RESERVE AT THE
BALLPARK, PHASE II,
AKA REVEL AT THE
BALLPARK
2885 CRESCENT PKWY
SMYRNA, GA 30080

SHEET TITLE AMENITY RESTROOM PLANS

A6-05

COMMENTS BUILDING PERMIT RE-SUBMISSION

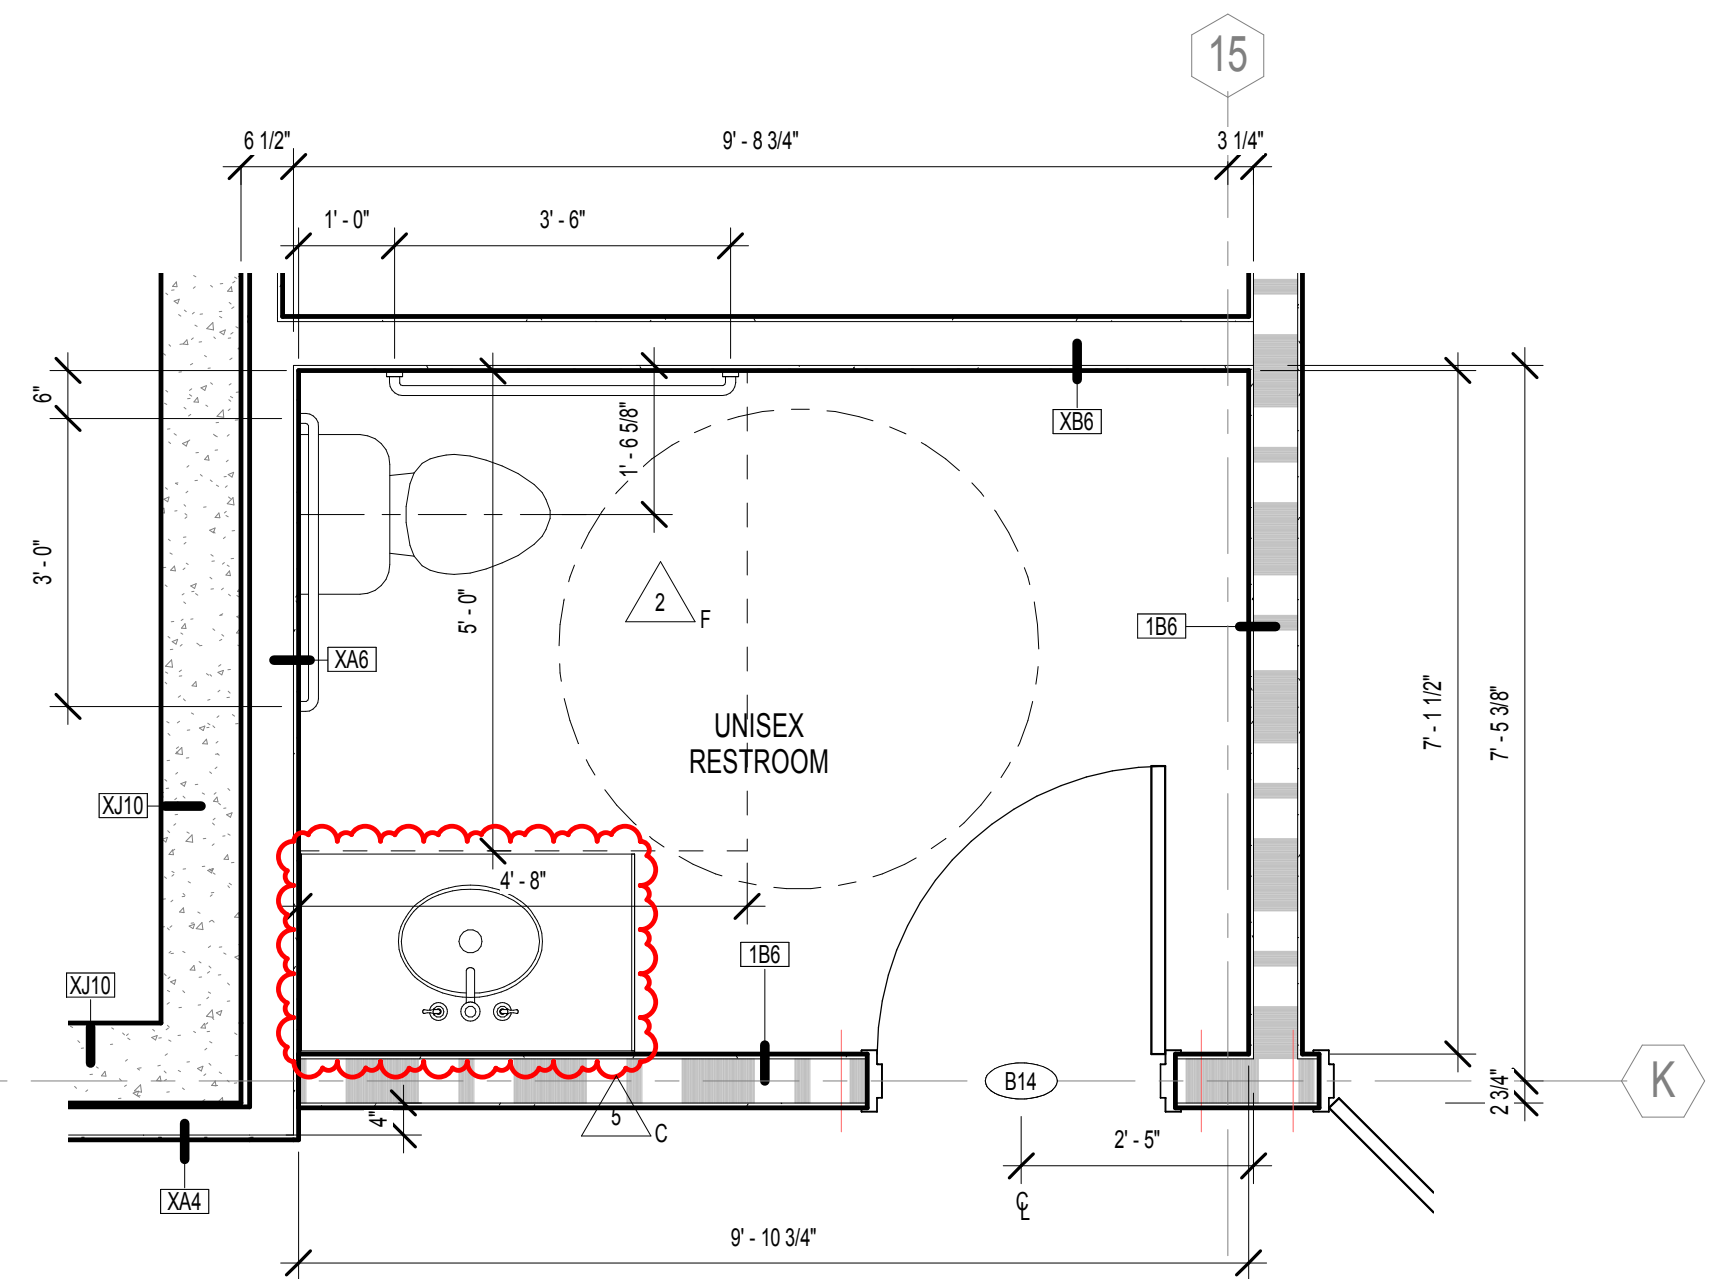
- A. ADDED NOTES
- B. ADDED ELEVATIONS
- C. MOVED THE WALL 2" TO ACCOMMODATE THE SHOWER IN MENS RRM. PROVIDED GRAB BARS AND SHOWER SEATS IN BOTH RRM'S
- D. MOVED TOILET IN THE MENS RRM TO PROVIDE 18" CLEAR
- E. MOVED THE TOILET IN THE WOMENS RRM TO PROVIDE 18" CLEAR
- F. MOVED TOILET IN THE UNISEX RRM TO PROVIDE 18" CLEAR

- A. ADDED URINAL PER HEALTH DEPT. COMMENT
- B. RELOCATED BABY CHANGING STATION
- C. LAV ROTATED TO PROVIDE 60" CLEAR WIDTH
